Appendix A: Request for Variance

Infrastructure Standards for Telecommunications Spaces v4.0

Request Date:	9/12/24
Government POC:	Tim Stark
Org Represented:	Castle Point VA Medical Center
Email Address:	Timothy.Stark@va.gov
Contact Phone:	914-776-4654
Site, Building #, Room, Mission of the Facility Where Requested (also note admin vs medical specific use):	Castle Point VA Medical Center B.15E - TR 011A & TR 315 B.16 - TR F100 B.17 - TR G-203 B.18 - TR 39
Variance Requested:	B.15E & B.15H - TR 011A serves both Buildings 15E and 15H. While technically separate buildings, 15E/H share corridors and exterior walls. There is ample coverage provided from a single TR serving both buildings. B.15E & B.15H - TR 315 serves attic. There is limited programming space on the 4th floor (attic); 3rd floor TR has sufficient capacity to serve any anticipated service needs in the attic. B.16 - TR F100 serves 2nd and 3rd floors. There is limited space available on the 2nd and 3rds floors due to programming needs. It is anticipated that ~75-100 ports are needed for the 1st, 2nd, and 3rd floors combined, which can be served appropriately from a single rack in F100. B.17 - TR G-203 serves the 2nd and 3

1 LEVEL 03 - FLOOR PLAN

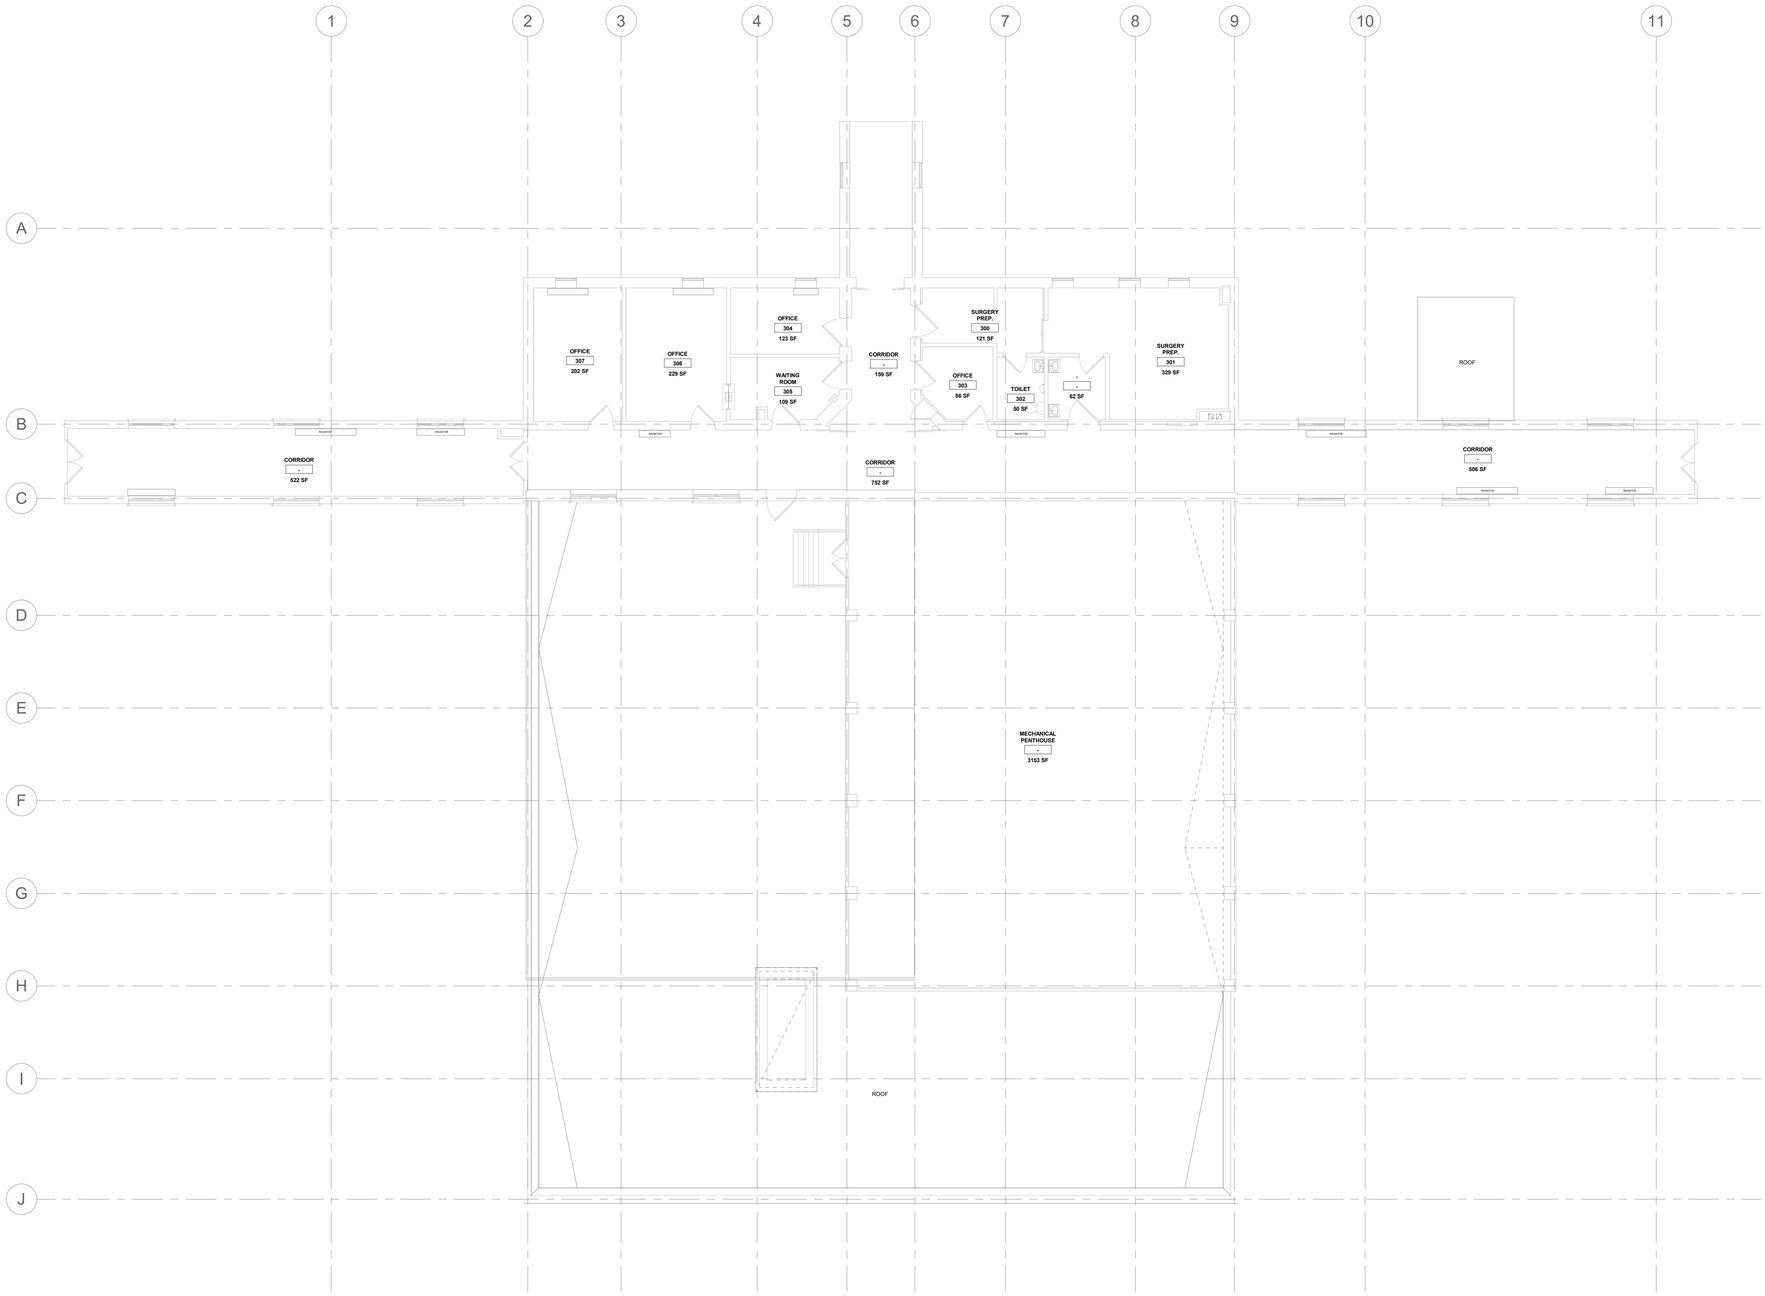
BLDG 16 - LEVEL 03
1. LIMITED PROGRAMMING NEEDS ON THIS FLOOR WILL BE SERVICED FROM TR 100 ON LEVEL 01.

1 LEVEL 00G - FLOOR PLAN

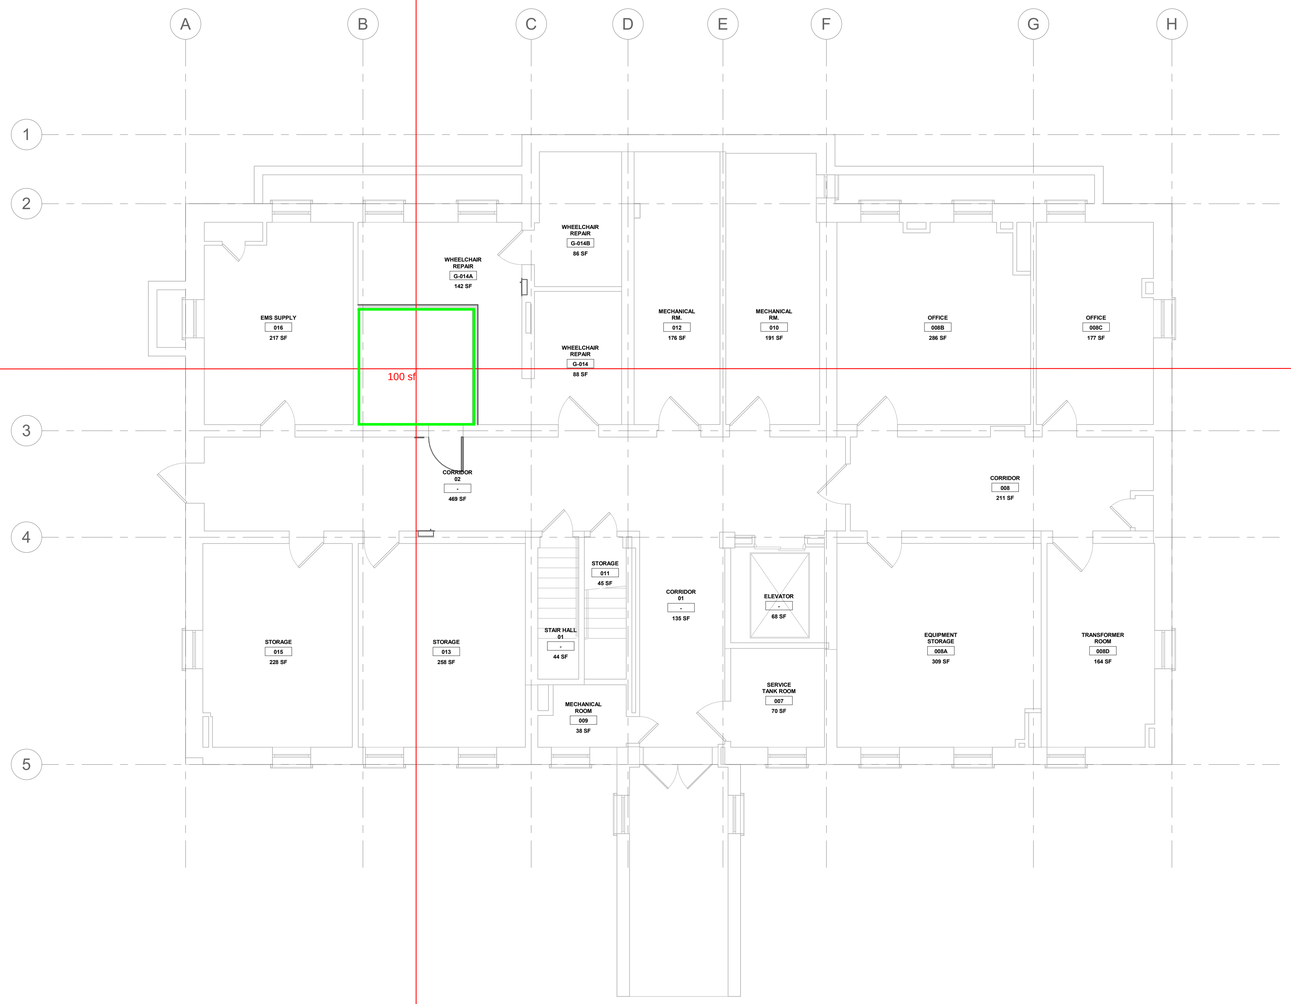
1. VA APPROVED TR G-014 (88 SQFT).
2. TR MEETS THE VA STANDARD FLOOR AREA REQUIREMENTS FOR EXISTING HEALTHCARE BUILDINGS OF 100 SQFT.
3. TR MEETS THE VA STANDARD MINIMUM FORM FACTOR REQUIREMENTS OF A 10'X10' FOOTPRINT.

1 LEVEL 01 - FLOOR PLAN
3/16" = 1'-0"

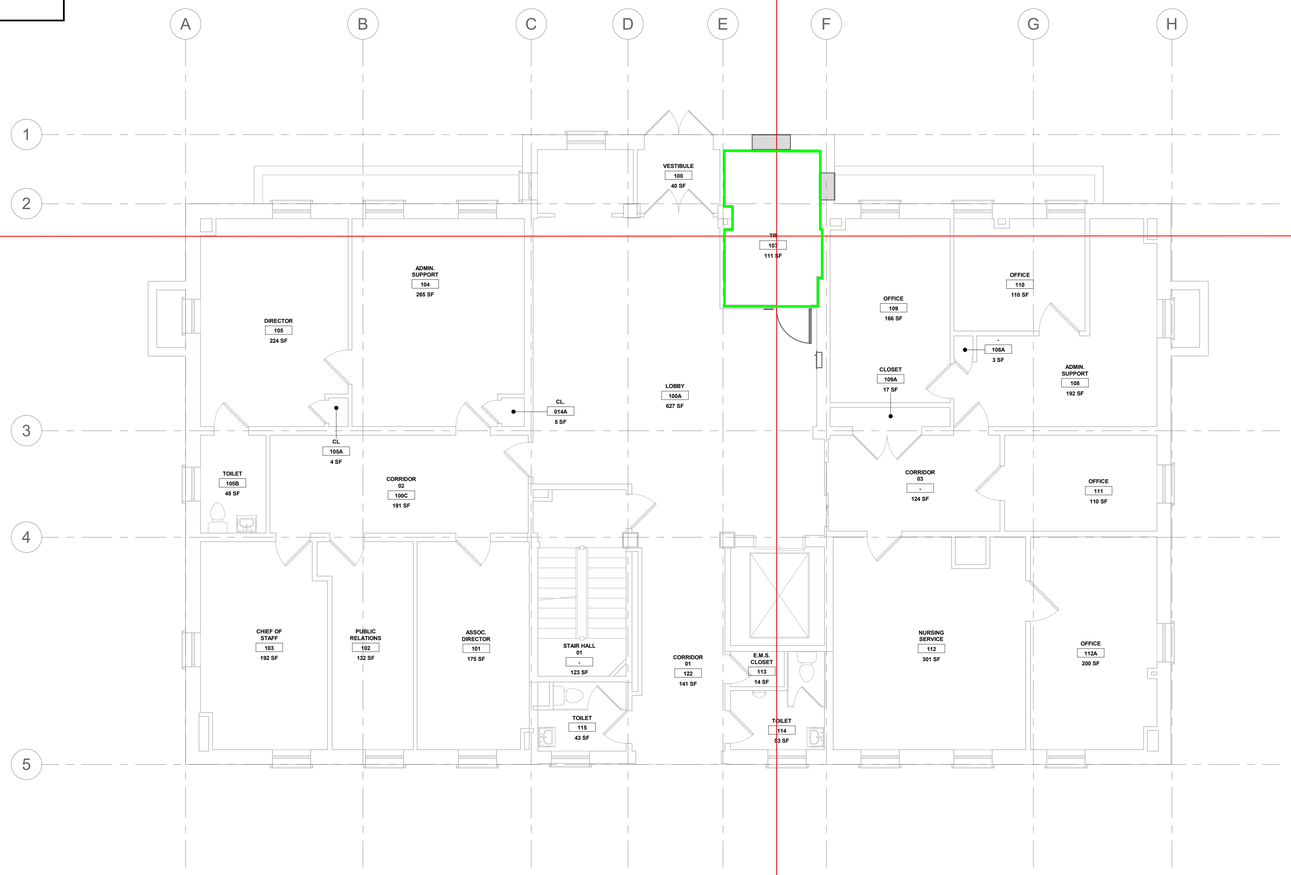
1. VA APPROVED TR 107 (111 SQFT).
2. TR MEETS THE VA STANDARD FLOOR AREA REQUIREMENTS FOR EXISTING HEALTHCARE BUILDINGS OF 100 SQFT.
3. TR DOES **NOT** MEET THE VA STANDARD MINIMUM FORM FACTOR REQUIREMENTS OF A 10'X10' FOOTPRINT.
4. SINGLE DIAMOND IS FOR SCALE REFERENCE.
5. OPTION 1: TR IN RM 112A

1 LEVEL 02 - FLOOR PLAN
3/16" = 1'-0"

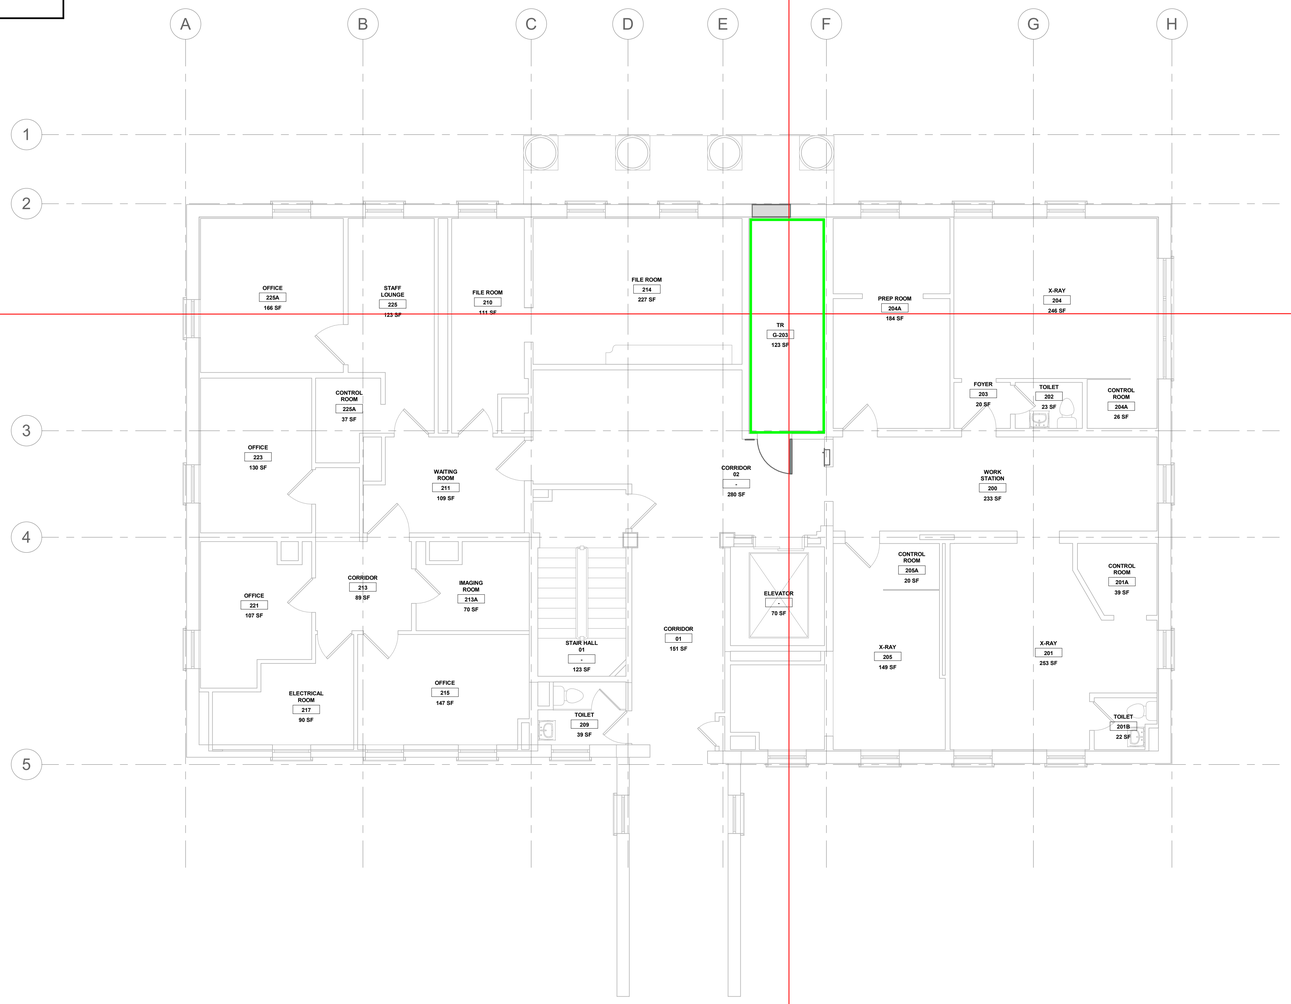
1. VA APPROVED TR G-203 (123 SQFT).
2. TR MEETS THE VA STANDARD FLOOR AREA REQUIREMENTS FOR EXISTING HEALTHCARE BUILDINGS OF 100 SQFT.
3. TR DOES **NOT** MEET THE VA STANDARD MINIMUM FORM FACTOR REQUIREMENTS OF A 10'X10' FOOTPRINT.
4. SINGLE DIAMOND IS FOR SCALE REFERENCE.
5. OPTION 1: TR IN FILE ROOM

1 LEVEL 03 - FLOOR PLAN

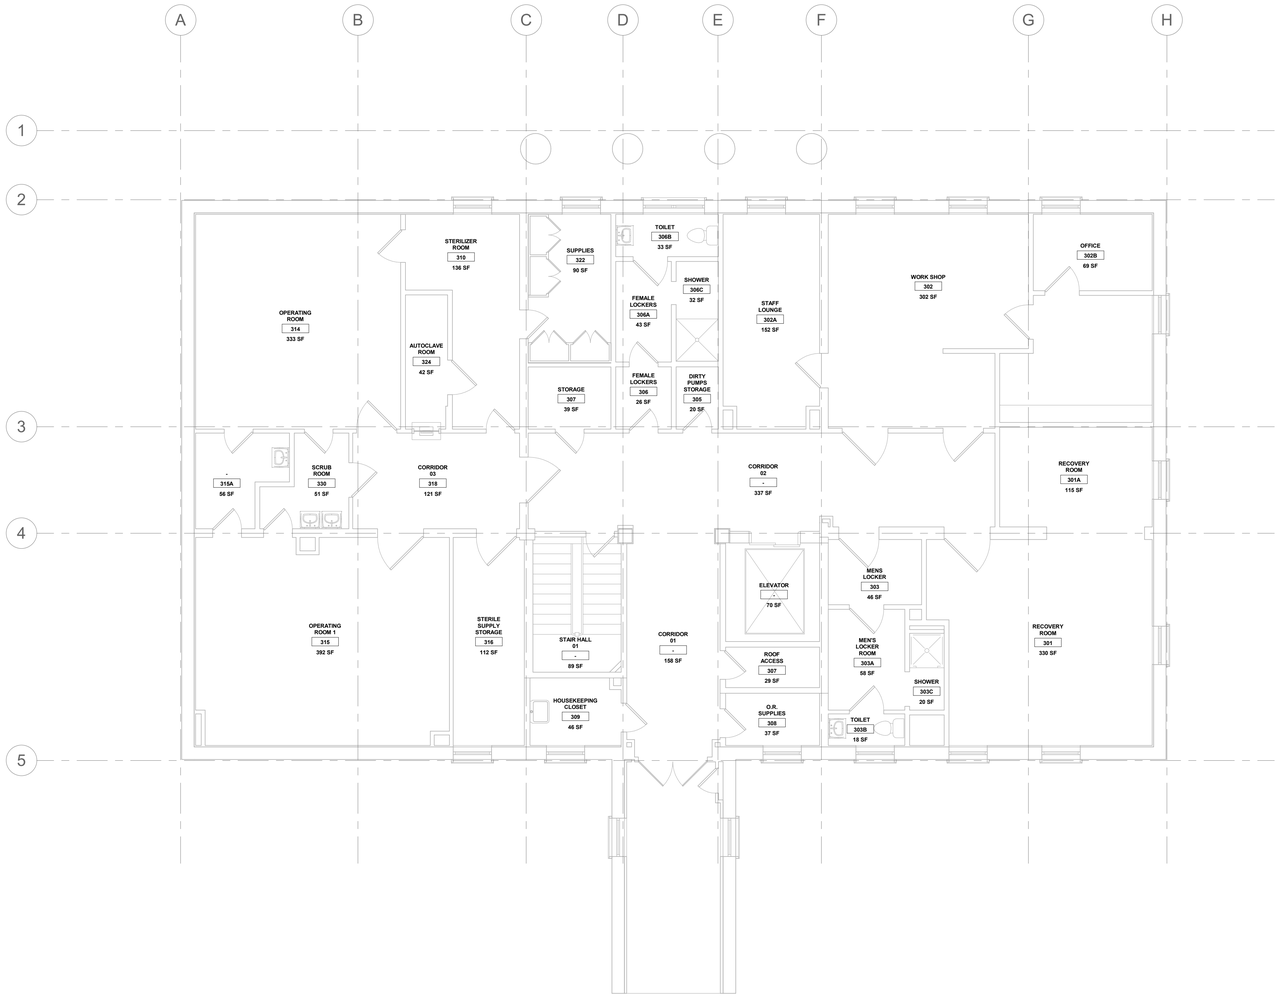
1. CURRENT SPACE IS STORAGE FOR LOGISTICS; VERY LIMITED PROGRAMMING. VARIANCE WILL BE PURSUED TO SERVICE FLOOR FROM TR G-203 ON LEVEL 02.

1 PENTHOUSE - FLOOR PLAN

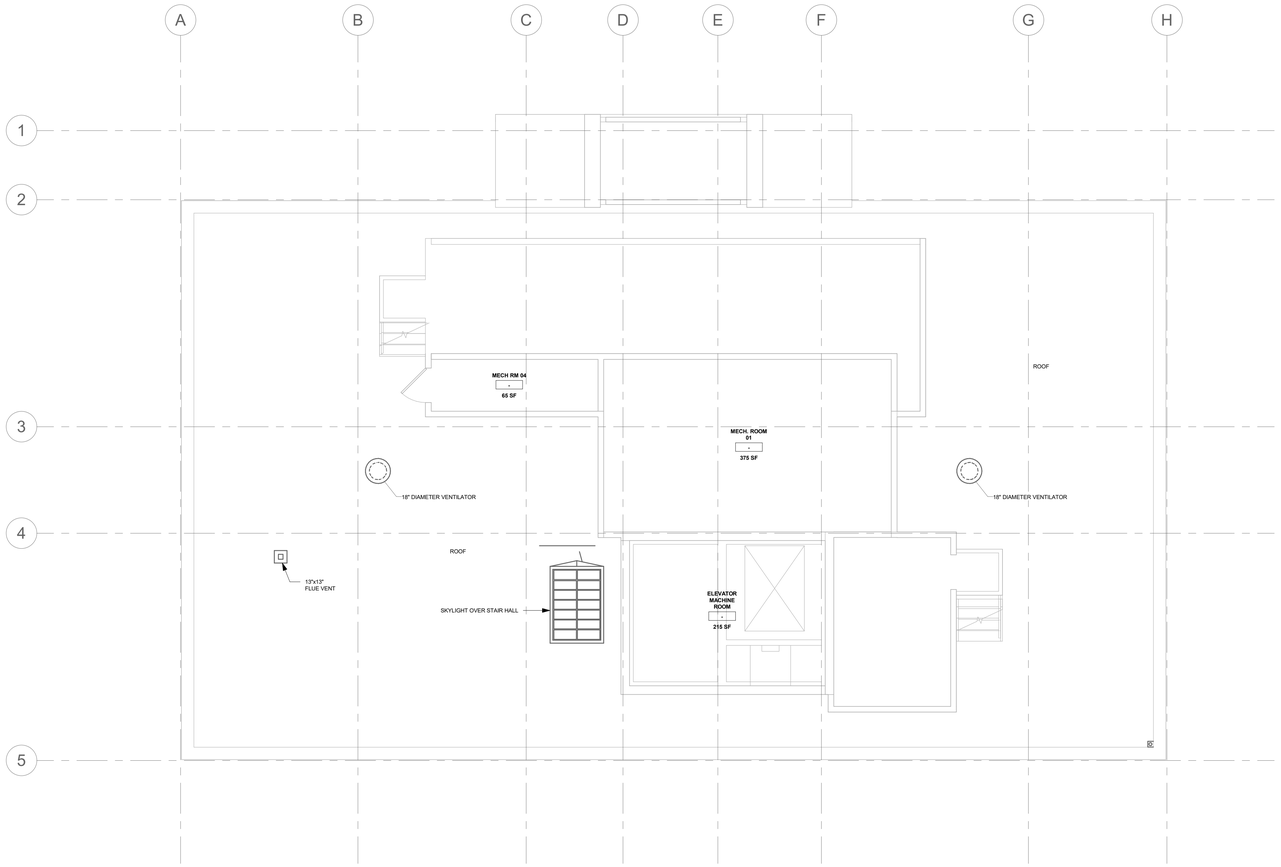
BLDG 17 - PENTHOUSE
1. CURRENT SPACE IS STORAGE FOR LOGISTICS; VERY LIMITED PROGRAMMING. VARIANCE WILL BE PURSUED TO SERVICE FLOOR FROM TR G-203 ON LEVEL 02.

1 LEVEL 00 - FLOOR PLAN
1/8" = 1'-0"

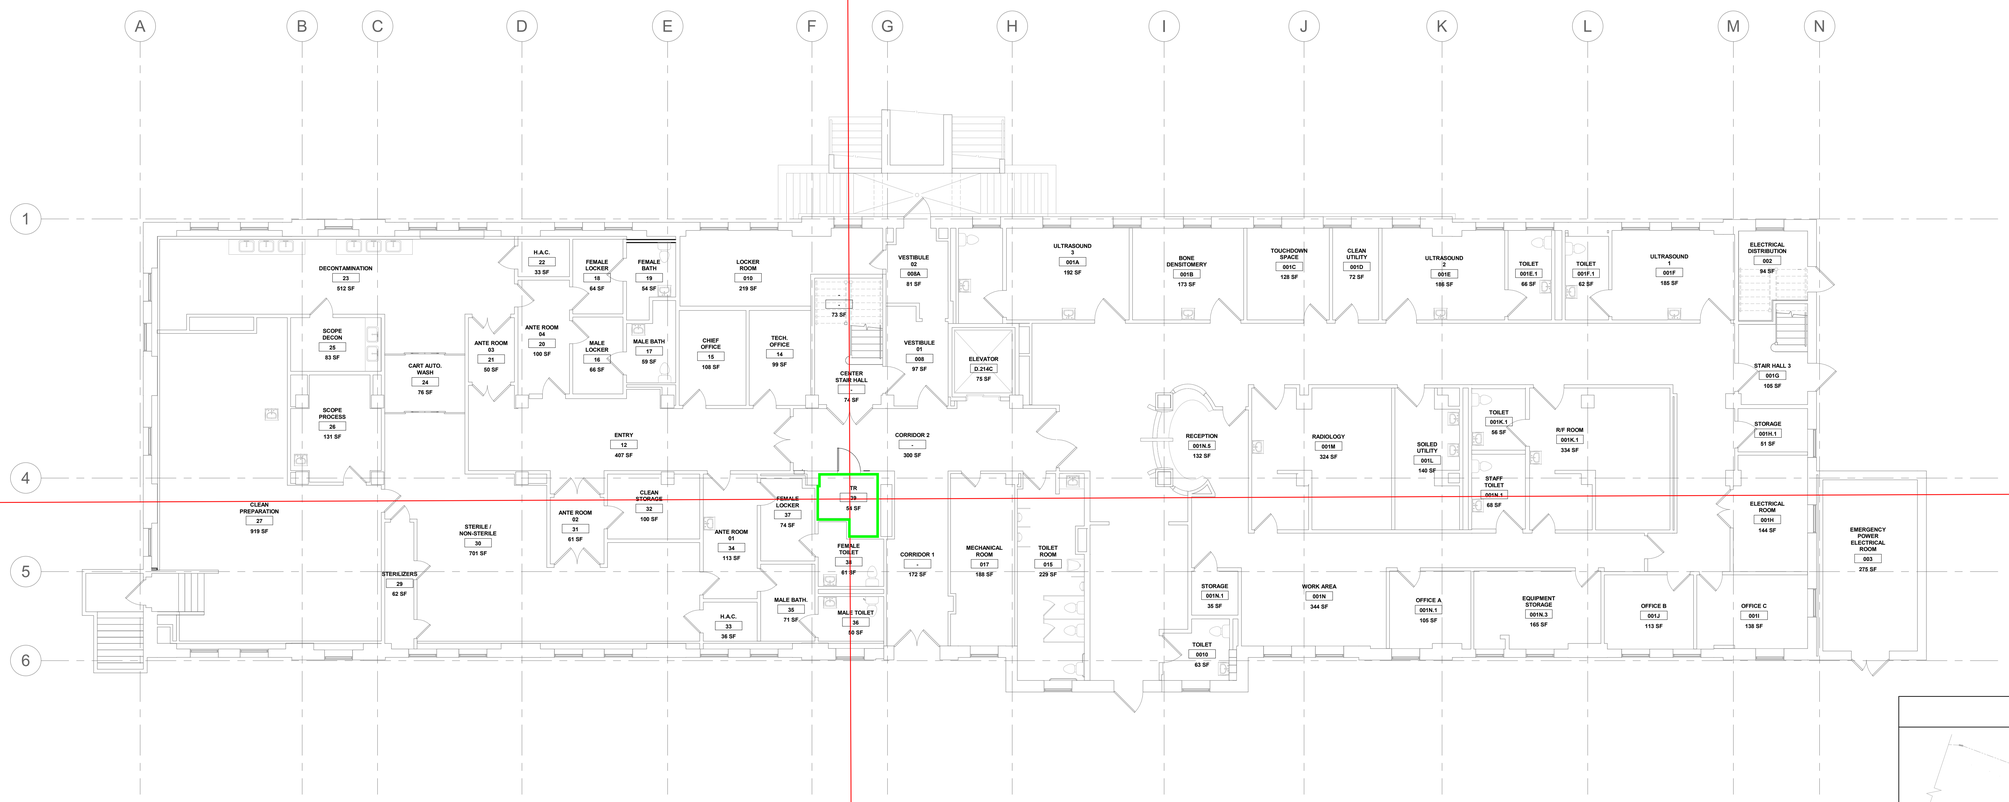
1. VA APPROVED TR 39 (54 SQFT).
2. TR DOES **NOT** MEET THE VA STANDARD FLOOR AREA REQUIREMENTS FOR EXISTING HEALTHCARE BUILDINGS OF 100 SQFT.
3. TR DOES **NOT** MEET THE VA STANDARD MINIMUM FORM FACTOR REQUIREMENTS OF A 10'X10' FOOTPRINT.
4. EXISTING TR TO BE EXPANDED IN AN EFFORT TO SUPPORT NEW SPS FROM EXISTING LOCATION IN ORDER TO PREVENT DISRUPTION TO NEW HARDLID CEILING.
